BERNALILLO COUNTY, NEW MEXICO
PUBLIC WORKS DEPARTMENT
CONSTRUCTION PLANS
FOR
INDUSTRIAL PARK WATER SYSTEM
WATER WELL AND PUMPING UNIT
BID PACKAGE A
BC PROJECT NO. TS 04-07-A

RECORD DRAWING

WATER WELL AND PUMPING UNIT
INDUSTRIAL PARK WATER SYSTEM
WELL AND PUMP DETAILS
BERNALILLO COUNTY

WELL LOCATION MAP

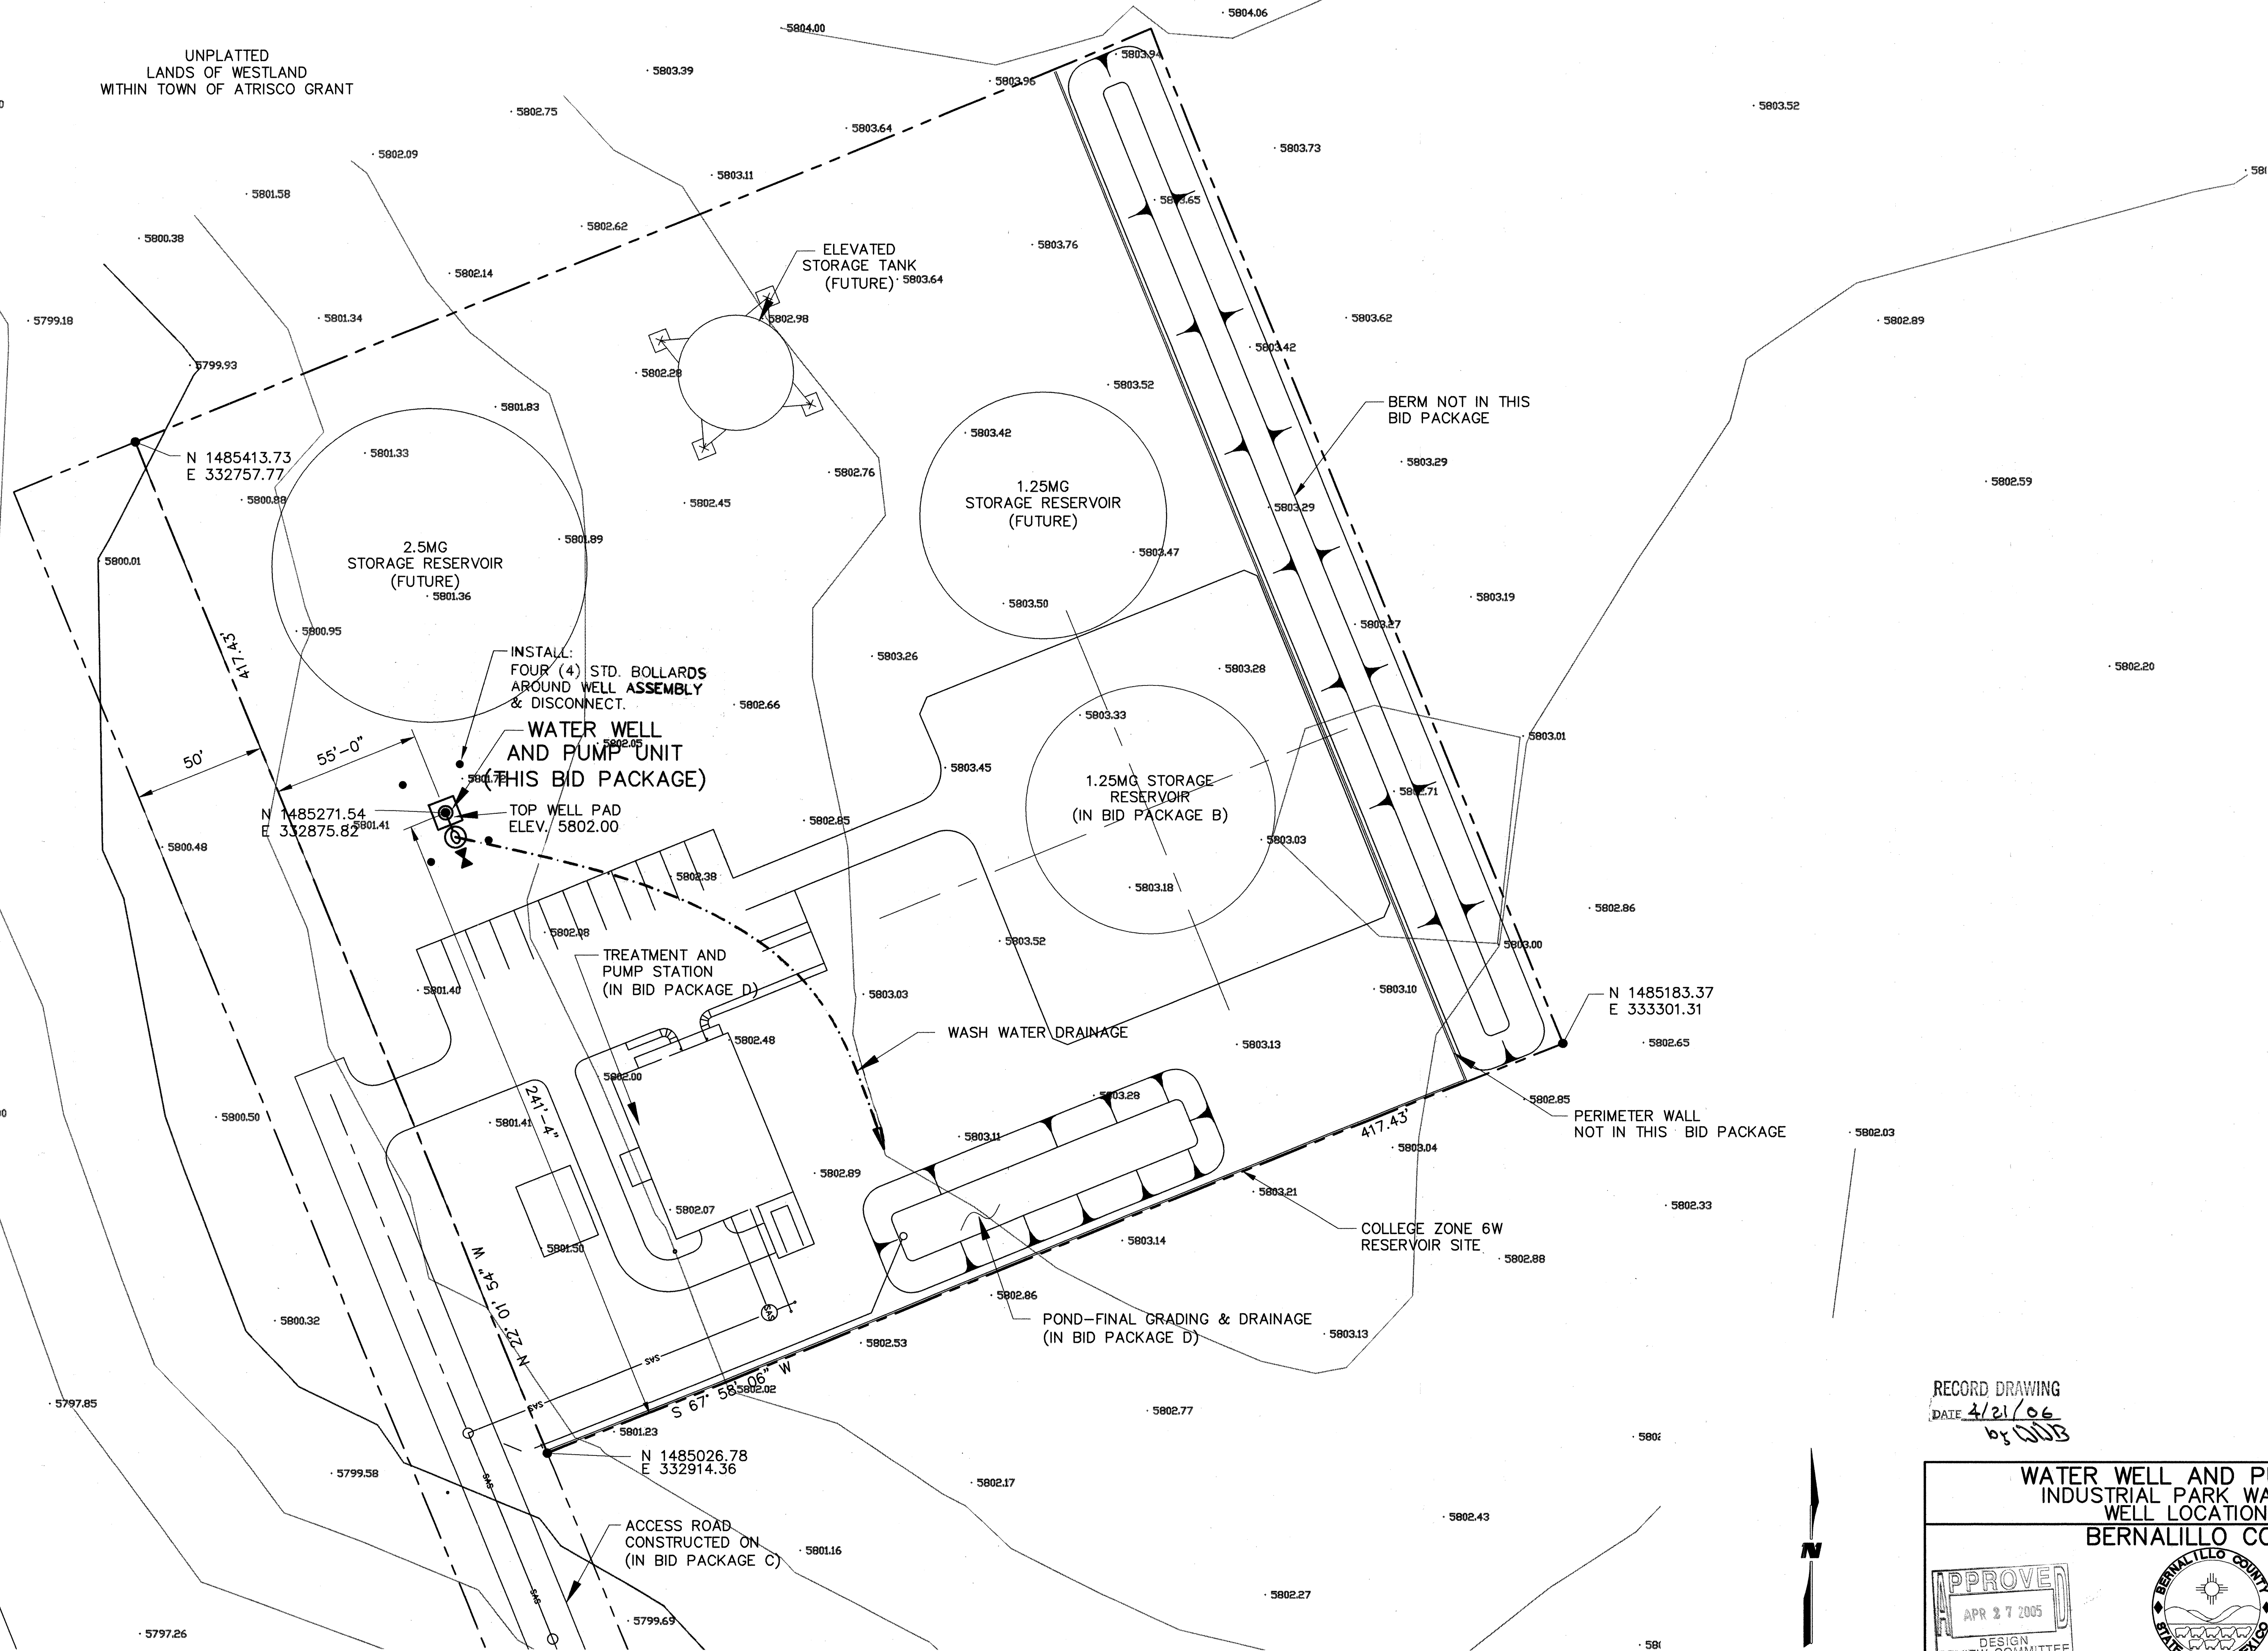
REVISIONS		REMARKS	
NO.	DATE	BY	REMARKS
1	4/21/06	CDB	DESIGN REVIEW COMMITTEE

1 SECTION - DRILLED WELL
NOT TO SCALE (AS CONSTRUCTED)

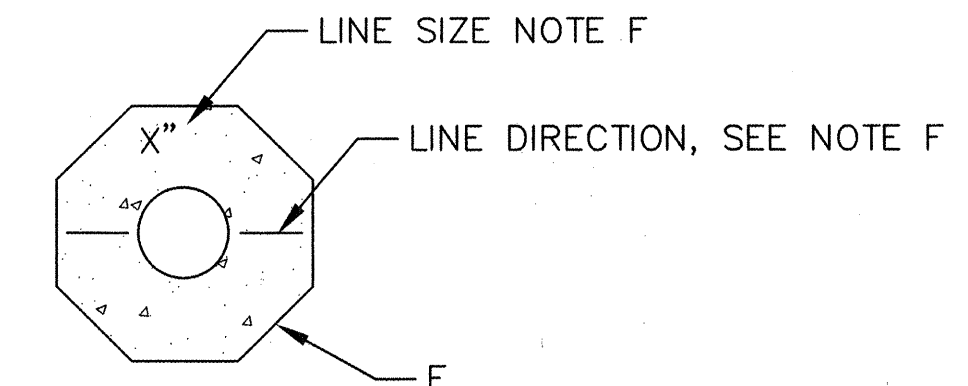
AS CONSTRUCTED

TOTAL DEPTH 1570 FT,
17 1/2" Ø
PILOT HOLE, THEN REAMED
TO 24" Ø FROM BOTTOM
OF CASING (TO FULL DEPTH.)
INSTALL 14" Ø X 5/16" WALL
HSLA BLANK CASING AND
14" Ø X 5/16" FULL-FLO HSLA
SHUTTER SCREEN (0.05" OPENINGS)
AS SHOWN. (SEE FINAL WELL
REPORT FOR DETAILS)

850' ESTIMATED 892' STATIC-ACTUAL
WATER LEVEL (AUG 31, 2005)

SEE REVISED NOTE "A"
BELOW

REVISED NOTE A: FINAL PUMP SELECTION: (DUTY POINT)
PUMP MOTOR CAPACITY OF 420 GALLONS PER MINUTE (GPM) AT
1128 FT OF TOTAL DYNAMIC HEAD (TDH) WITH 175 HP MOTOR,
(PRIMARY DUTY POINT). FINAL SELECTION IS CHISTENSEN PUMP
SUBMERSIBLE, #SST - 7CSHC (11 STAGES) 3600 RPM, WITH
STAINLESS-STEEL BOWL ASSEMBLY, 6" NPT DISCHARGE CONNECTION,
SUBMERSIBLE VERTICAL TURBINE PUMP (FULL SERIAL NUMBERS
(505031-2 PUMP & 05L19-01-8010 MOTOR)

REVISED NOTE D: A PITLESS ADAPTOR, "BASKI" MODEL
EHD-S-14X6-6F7APIR WT 4.5-2-RT-2SSP AS REQUIRED WITH
SEALED ELECTRICAL CONDUIT AND PROBE CONNECTIONS, IS
PROVIDED FOR PUMP DISCHARGE HEAD.

- WELL HEAD – GAGE, FILL AND CHEMICAL FEED LINES
NOT TO SCALE

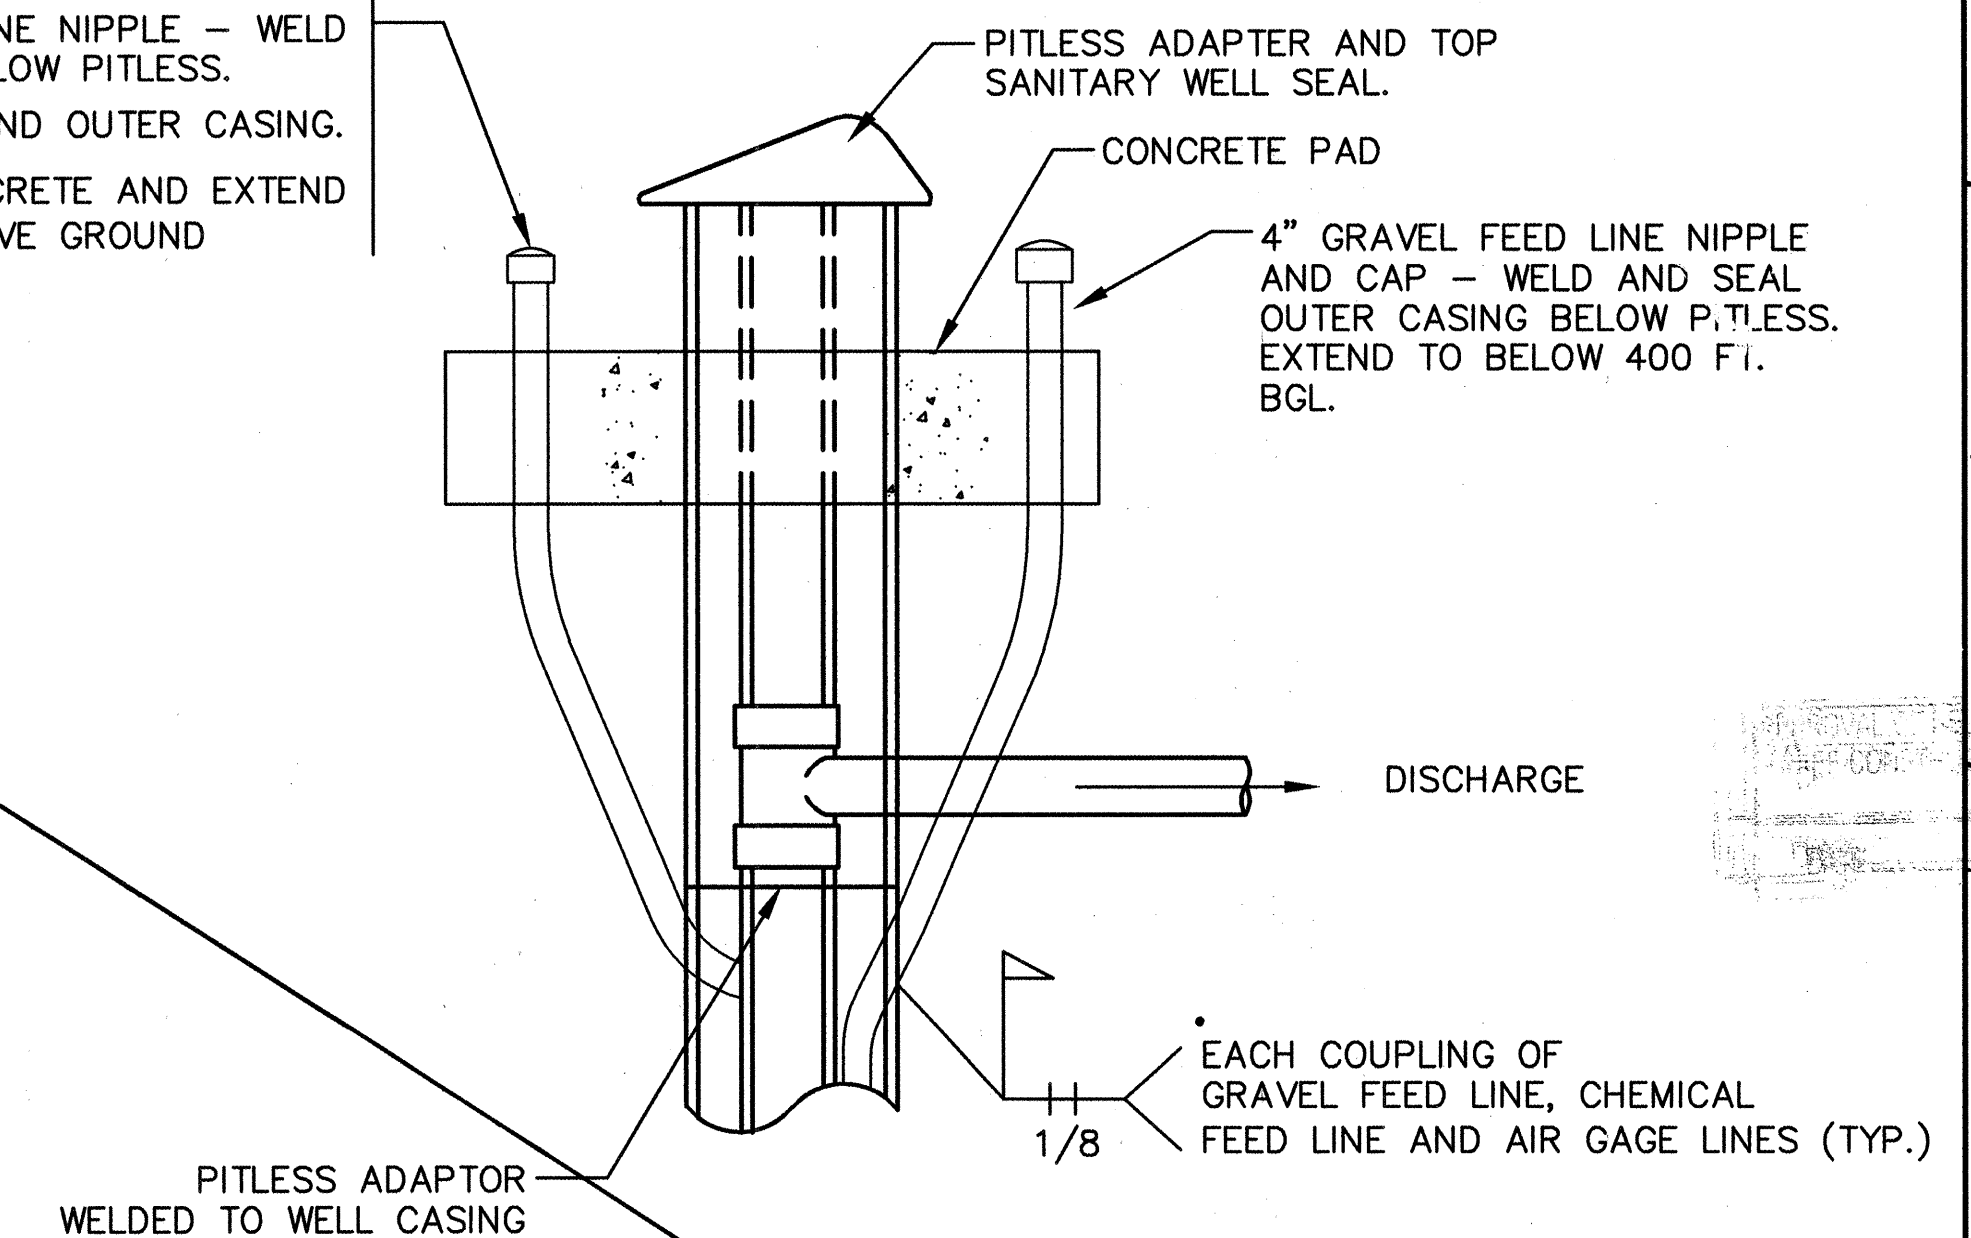
PER ADDENDUM # 2
5/02/05
